Subject: Alternative Core Supplier.

PCN-01281

MABA-007159-000000

PCN Number: PCN-01281		PCN Date: September 20 th 2019
Title: Alternate Core supplier for P/N MABA-007159-000000 needed due to significant price increase of core material from primary supplier. This effort is to maintain the current price provide to customer.		
Proposed 1st Ship Date: Dec 20th 2019		Estimated Sample Availability: Samples available upon request
Change Type:		
Assembly Site	Design	Electrical Specification
Test Site	Assembly Process	Mechanical Specification
Test Process	Assembly Materials X	Packing/Shipping/Labeling
PCN Details		
Description of Change:		
MACOM has identified a second source for the core used on MABA-007159-000000.		
MABA-007159-000000		
Current Core		Alternative Core

Appendix I: MABA-007159-000000 Electrical test data(at 25°C as per datasheet)

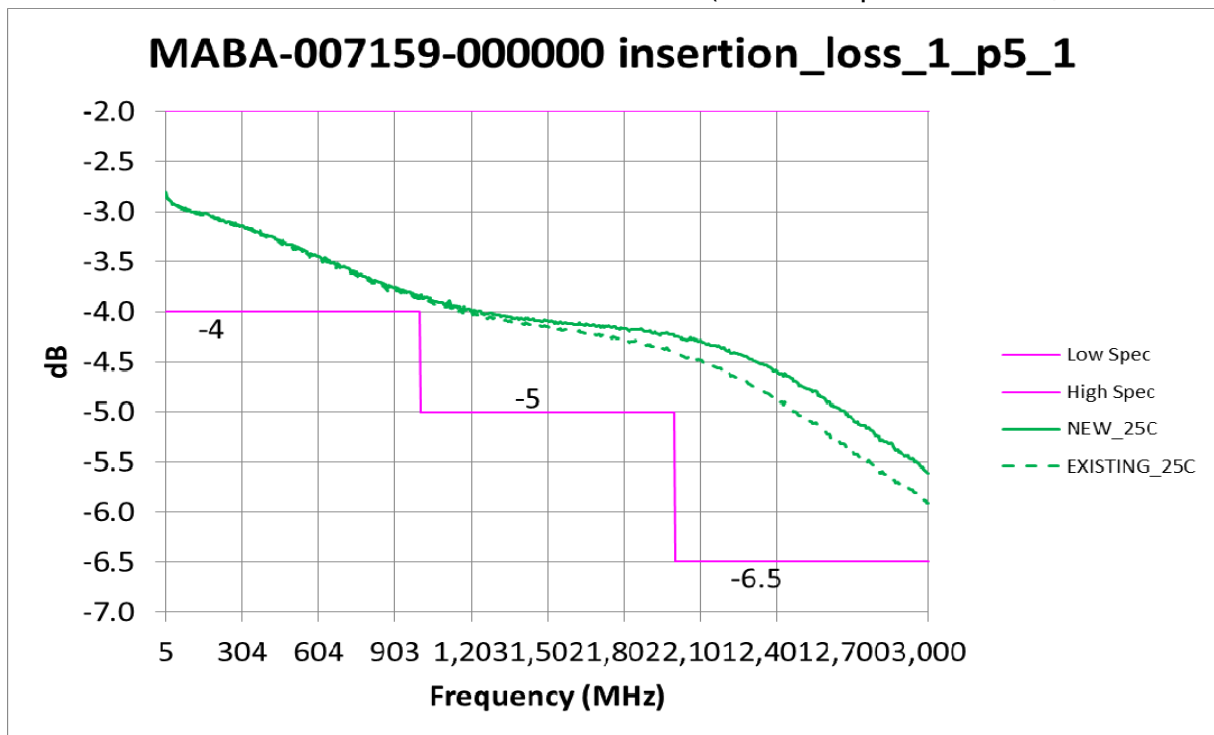
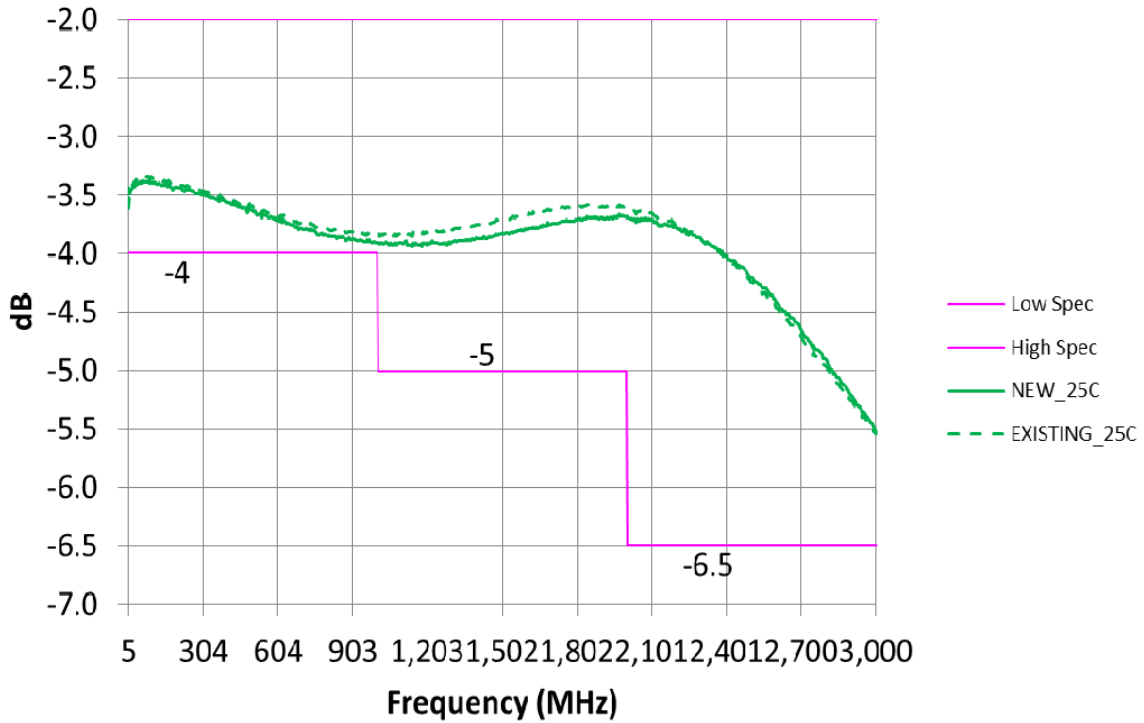
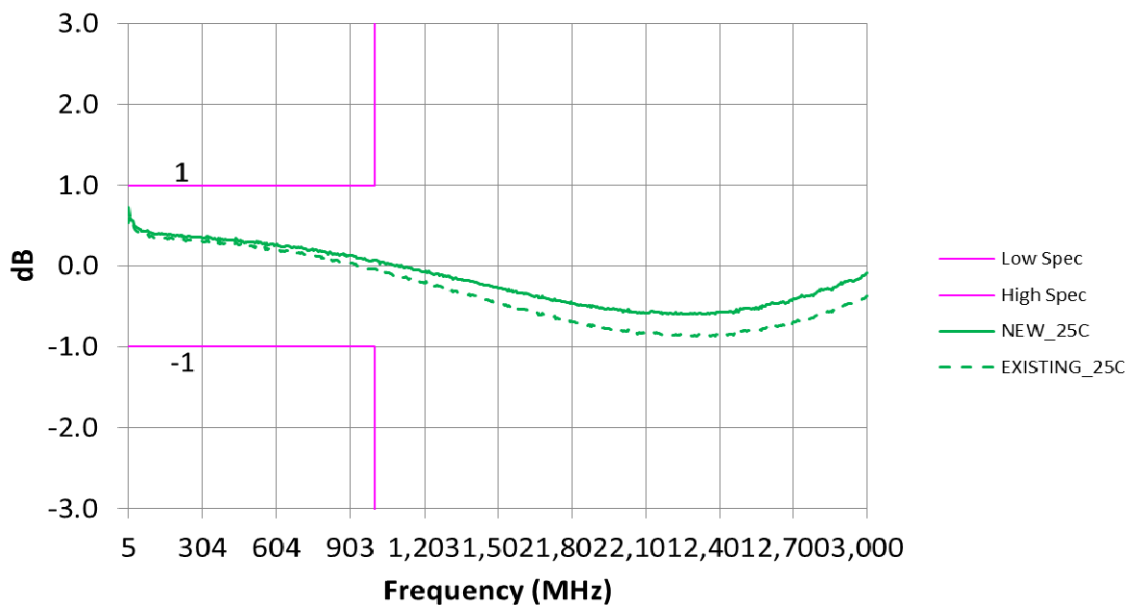
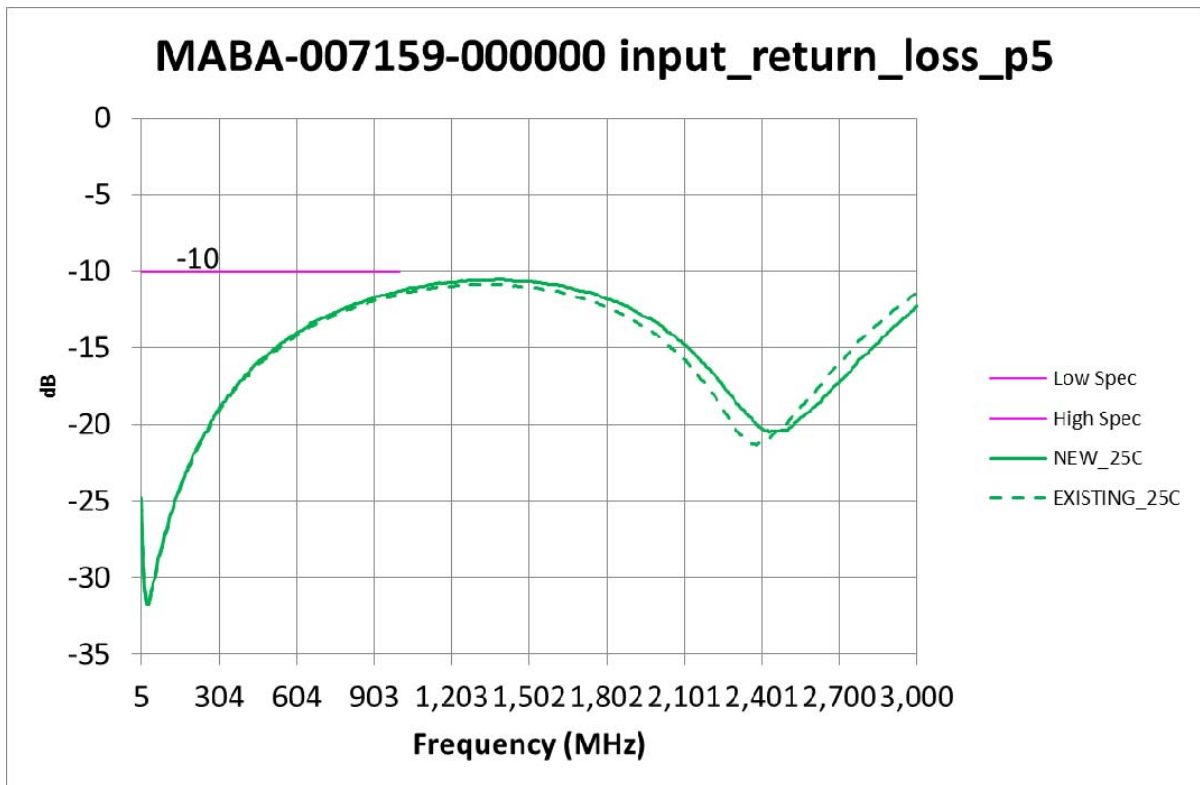
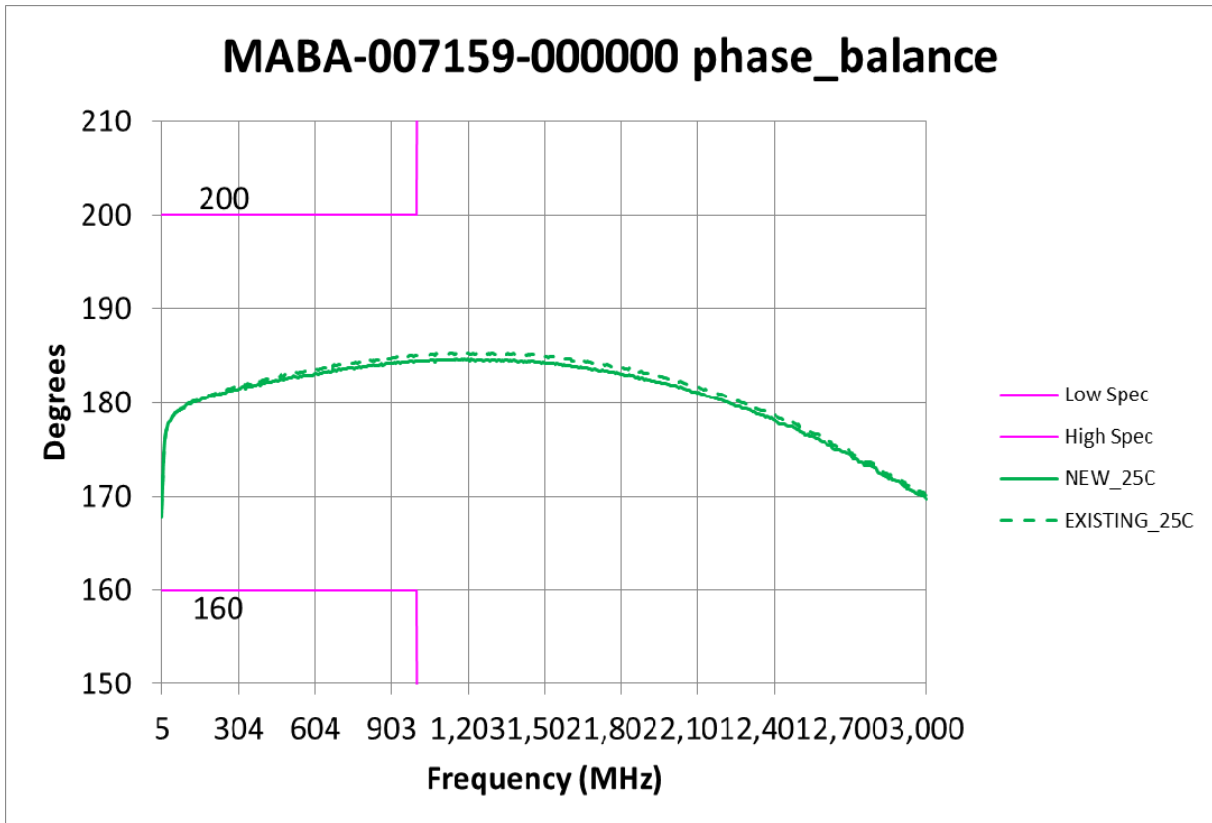
A comparative analysis was performed which showed no significant shift in electrical/mechanical parameters between transformers using the current and second source supplied core.
